**Enclosure 6 to E-54257**

**SAR Changed Pages  
(Public Version)**

**Figure 2-3**  
**Proposed WCS CISF 5-mile Radius**

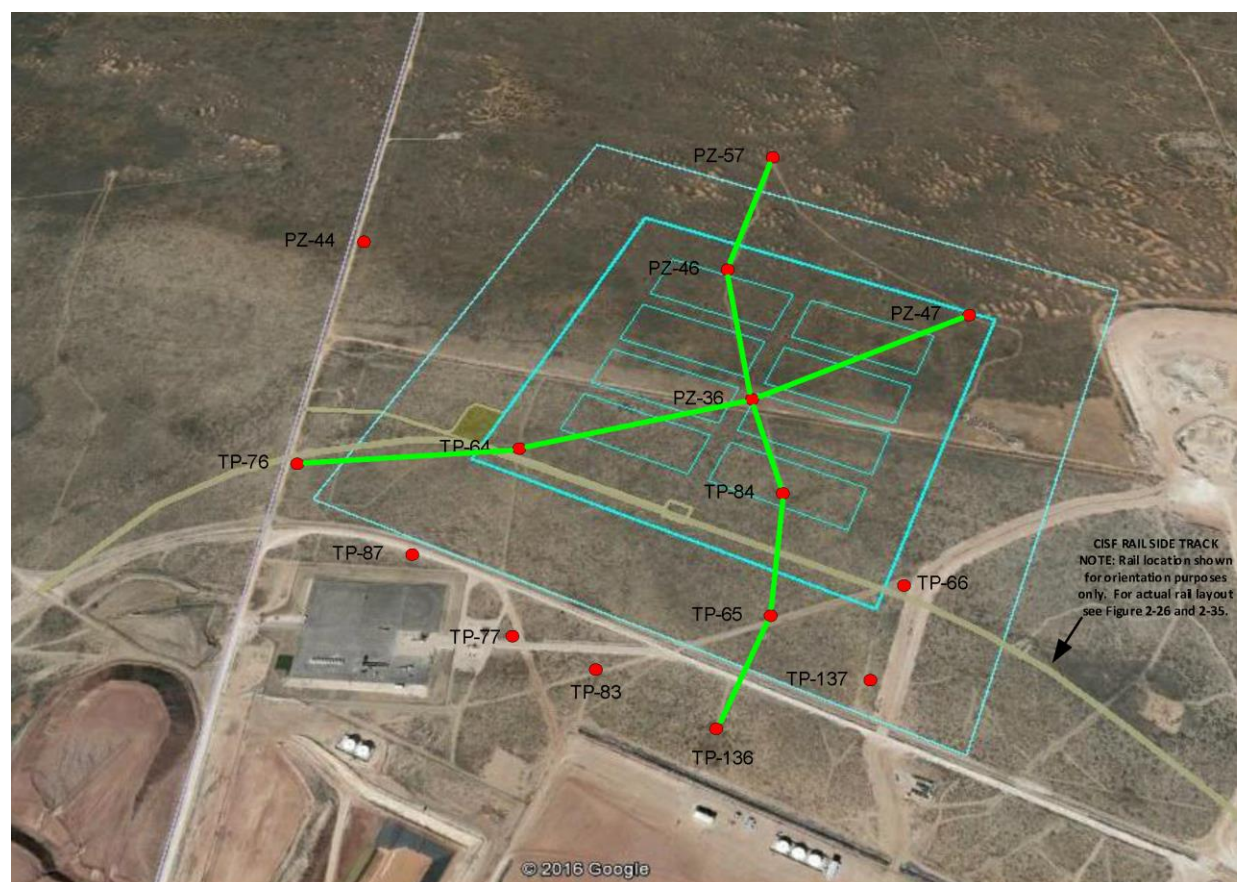
The only industrial facilities located within *five* mile of the WCS CISF boundary are URENCO USA, Permian Basin Materials, *the Lea County landfill, a future travel stop* and Sundance Services, Inc. (Figure 2-3). URENCO USA is a uranium enrichment facility that uses centrifuge technology to provide uranium enrichment services. Waste Control Specialists operates several permitted and licensed facilities immediately south of the WCS CISF, including a RCRA landfill, a low-level radioactive waste facility and a byproduct materials landfill. *The WCS Facilities include several fuel (diesel, gasoline, and propane) tanks used for fueling heavy equipment and facility operations. Tanks range in size from 350 gallons to 8,000 gallons.*

*Construction has started on a travel stop operated by Love's Travel Stops & Country Stores located at the intersection of New Mexico State Highway 18 and Hwy 176. This facility, which will provide fuel for highway vehicles, is located more than 3.5 miles from the WCS CISF.*

*The Waste Control Specialists rail spur and loop exits the Texas & New Mexico Railway near Eunice, New Mexico as shown in updated SAR Figure 2-3. This spur continues east until it reaches the existing Waste Control Specialists facility where it forms a loop around the facility. The rail side track to the WCS CISF will begin by connecting to the northwest side of the existing loop and terminate by re-connecting at the north side of the loop. This rail line is completely controlled by ISP joint venture member Waste Control Specialists and limited to approved Waste Control Specialists waste shipments and transport casks. Railcars carrying contents with the potential to adversely affect the CISF will not be permitted on the Waste Control Specialists rail spur and loop. Fire and explosion precautions for the WCS CISF rail side track are discussed in Section 3.3.6 of the SAR.*
